Petition No. 2020-
Petitioner: Charlotte Planning, Design and Development

**AN ORDINANCE AMENDING APPENDIX A OF
THE CITY CODE –ZONING ORDINANCE**

C. Shared Use Path *

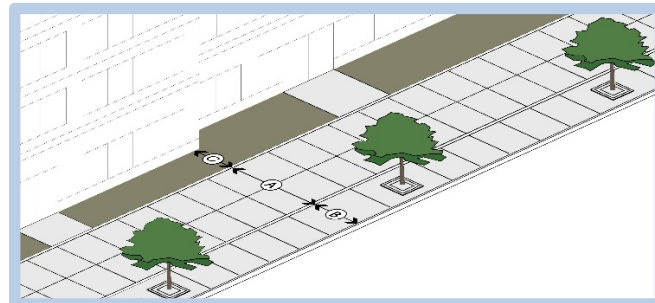
26. Amend Section 15.4.4, “Pedestrian Facilities and Planting Strip/Amenity Zone Standards”, subsection C, “Shared Use Path” by 1) replacing the graphic and caption, 2) modifying the minimum dimensions, and 3) adding and modifying asterisks. The revised graphic and caption shall read as follows:

Shared Use Path and Amenity Zone Dimensions **

Minimum Dimension
<u>A</u>	Shared Use Path	12'
<u>B</u>	Amenity Zone <u>***</u> or Perimeter Planting Strip	8' on outer and 4' on inner
<u>C</u>	<u>Amenity Zone ****</u>	<u>4'</u>

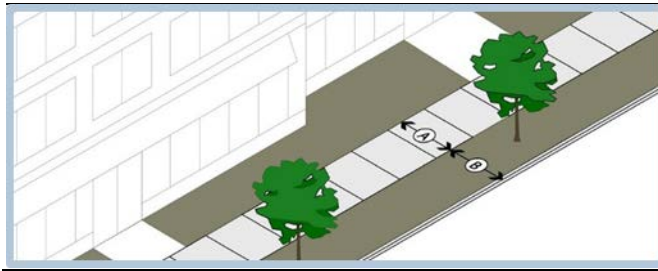
27. Amend Section 15.4.4, “Pedestrian Facilities and Planting Strip/Amenity Zone Standards”, subsection D, “Greenway Trail”, by modifying the asterisk as follows: 1) delete the second sentence in the first paragraph; 2) delete the first sentence of the second paragraph; 3) modify the last sentence of the second paragraph as shown; and 4) add a new sentence at the end of the third paragraph. The revised subsection shall read as follows:

- * The requirement for a greenway trail will be identified in an adopted Mecklenburg County Greenway Master Plan. ~~If the adopted plan does not adequately determine the trail requirement, the requirement will be determined by the Director of Mecklenburg County Park and Recreation, in Greenway dimensions are to be determined by the Director of Mecklenburg County Park and Recreation and/or the CDOT Director. However, the~~ Greenway trails shall be a minimum of 12’ in width and located no closer than 4’ from any building.

The requirement for construction of a greenway trail may be waived by the Director of Mecklenburg County Park and Recreation and/or the City of Charlotte if either agency has plans for construction of the same trail. In such instances the development shall be required to dedicate the land necessary to accommodate the trail in the location and with the typical dimensions specified in the latest design plans for that project.

I. Cross Charlotte Trail (XCLT)*

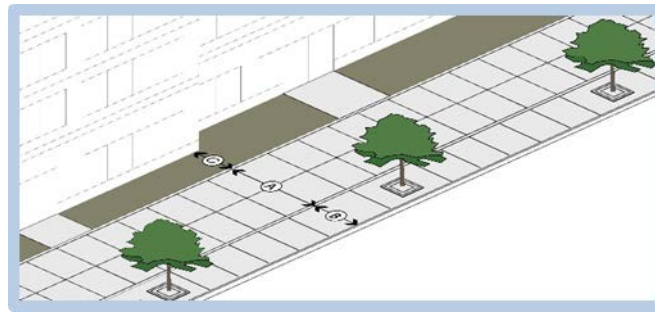
30. Amend Section 15.4.4, “Pedestrian Facilities and Planting Strip/Amenity Zone Standards”, by adding a new subsection I, titled “Cross Charlotte Trail (XCLT)*” that includes a new graphic, text and table. The new subsection shall read as follows:

Cross Charlotte Trail and Amenity Zone Dimensions**

Minimum Dimension
A	Shared Use Path	16'
B	Amenity Zone *** or Perimeter Planting Strip	8' on outer and 4' on inner
C	Amenity Zone ****	4'
